ESR Horsley Logistics Park - SSD
Horsley Park, NSW
Project No: 200224

Response to Jacafin Visual Impact Assessment – Urbaine Architectural

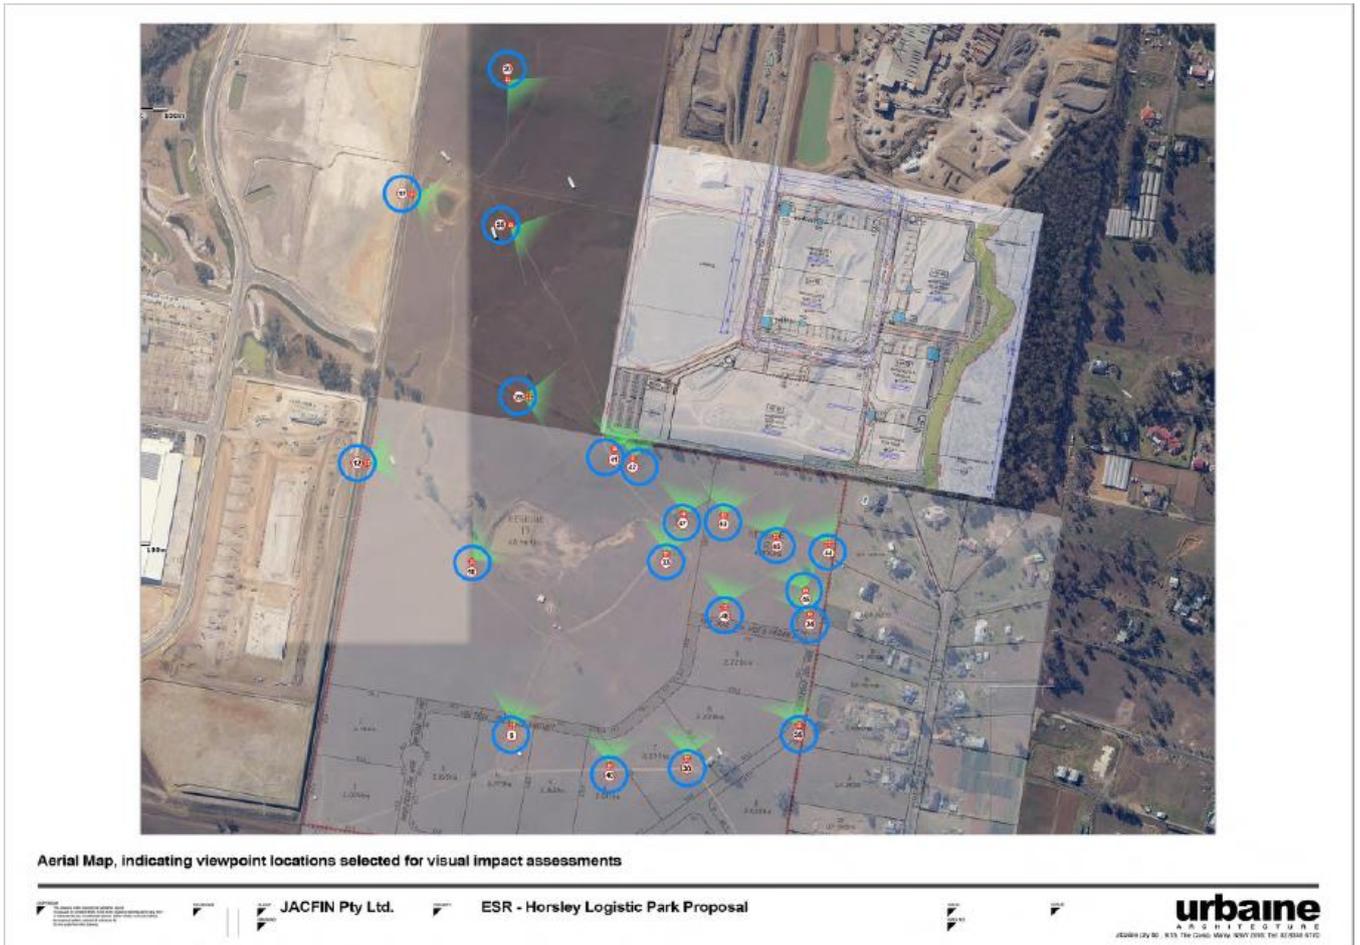
HWL Ebsworth Lawyers in their letter address to Bruce Zhang and dated 26th August note the following:

'The Landscape Master Plan prepared by Geoscapes dated 15 June 2020 indicates that the management of the southern landscape buffer will be managed by others. The Application must be amended to correct this error and to confirm that the Proponent will be responsible for the maintenance of the vegetated area on the southern boundary of the Site, including the maintenance of the gabion retaining walls, in accordance with the Court Approval.'

Geoscapes masterplan SSD-01 has the following note 'Southern landscape buffer (by others)'. This is in reference that the southern buffer has been **designed** by others within the approved DA 893.1/2013 and therefore, one should refer to the documentation relevant to the DA for further details of

the planting and treatments to this area. The note in our opinion does not imply that the management of this area will not be maintained currently and into the future by the proponent.
